# TECHNICAL SERVICE BULLETIN

Classification: EL26-003	Reference: NTB26-016	Date: March 30, 2026
-----------------------------	-------------------------	-------------------------

## DEFROST FEATURES UNAVAILABLE IN APP DUE TO SHORTING TERMINAL POSITION

**APPLIED VEHICLES:** 2026 LEAF (ZE2)  
**APPLIED DATES:** Built on or before August 14, 2025

Figure 5

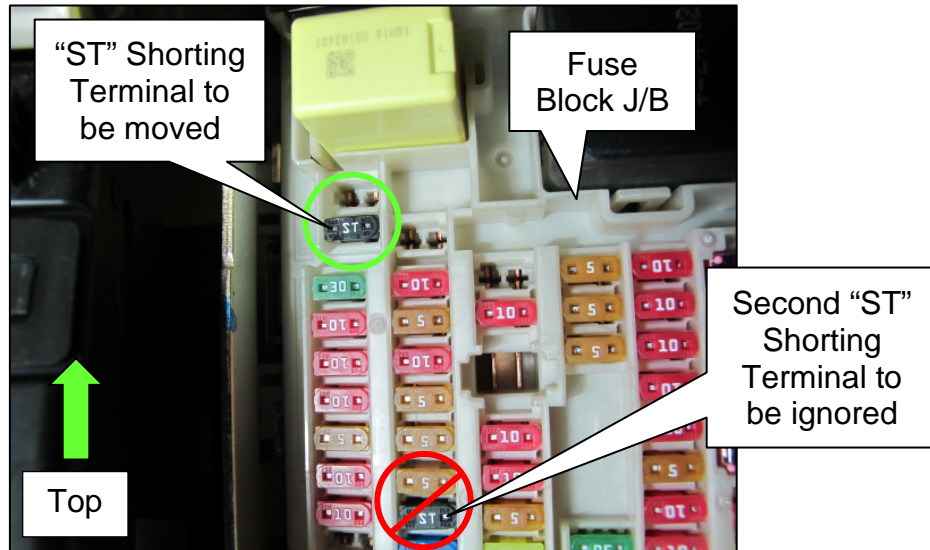
5. Locate the “ST” Shorting Terminal in the upper left corner of the Fuse Block J/B.

- There are two (2) black “ST” Shorting Terminals in the Fuse Block J/B.
- This procedure applies only to the “ST” Shorting Terminal in the upper left corner of the Fuse Block J/B.

Figure 6

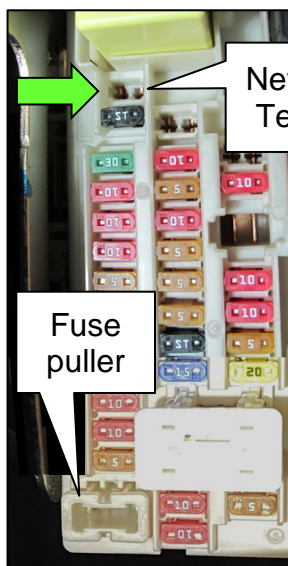
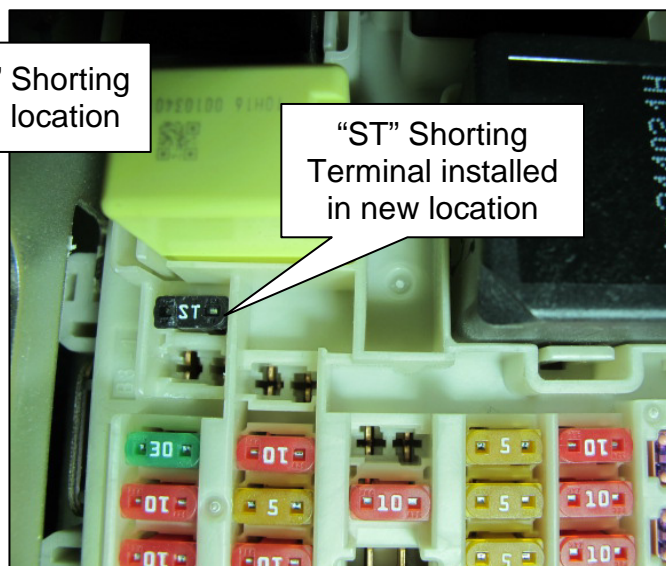
6. Remove and relocate the black “ST” Shorting Terminal UP one position in the upper left corner of the Fuse Block J/B.
- Use a fuse puller or another suitable tool to remove and re-install the “ST” Shorting Terminal UP one position, as shown in Figure 6 and Figure 7.
  - Verify the “ST” Shorting Terminal is fully seated.
